**IEEE P802.15
Wireless Personal Area Networks**

Project	IEEE P802.15 Working Group for Wireless Personal Area Networks (WPANs)	
Title	TG3 Recommended D10 changes in support of ballot comments	
Date Submitted	1 August, 2002	
Source	Jay Bain Time Domain7057 Old Madison Pike Huntsville, AL 35801	Voice: 256 922-9229 Fax: 256 922-0837 E-mail: jay.bain@timedomain.com
Re:	IEEE Draft P802.15.3/D10	
Abstract	This document is a supplement to the authors D10 ballot response and provides recommended changes to D10. Most of the text is related to Child and Neighbor piconets. Revision 1 includes child/neighbor resolutions of additional comments.	
Purpose	Accepted recommendations from this document would be placed in D11 .	
Notice	This document has been prepared to assist the IEEE P802.15. It is offered as a basis for discussion and is not binding on the contributing individual(s) or organization(s). The material in this document is subject to change in form and content after further study. The contributor(s) reserve(s) the right to add, amend or withdraw material contained herein.

Figure 3—MSC for the creating a child piconet.

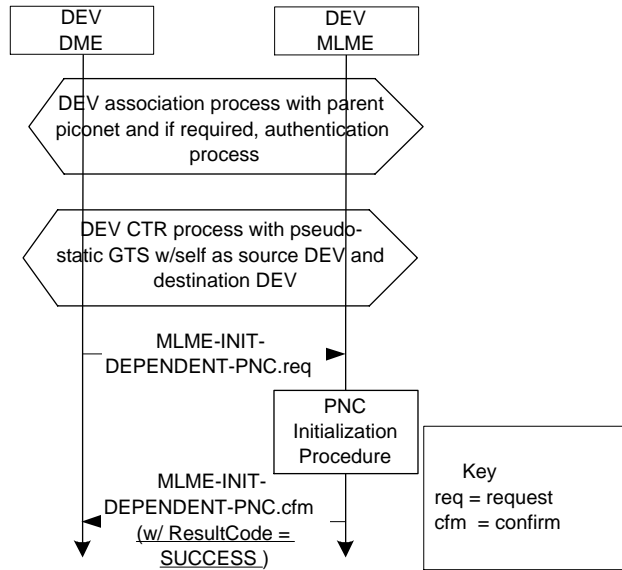
This revision does not include the graphics changes yet. The two figures for the setup of child and neighbor piconets require change. A different commenter recommended that true MSCs be used in place of the current style.

{notes for the MSC. Should we use DEV or should we use PNC in header titles? Should we show the initial beacon after the PNC initialization procedure block. }

The MSC for creating a child piconet is illustrated in Figure 3. {xref to Association and CTR processes by way of explaining the hex blocks in the figure}
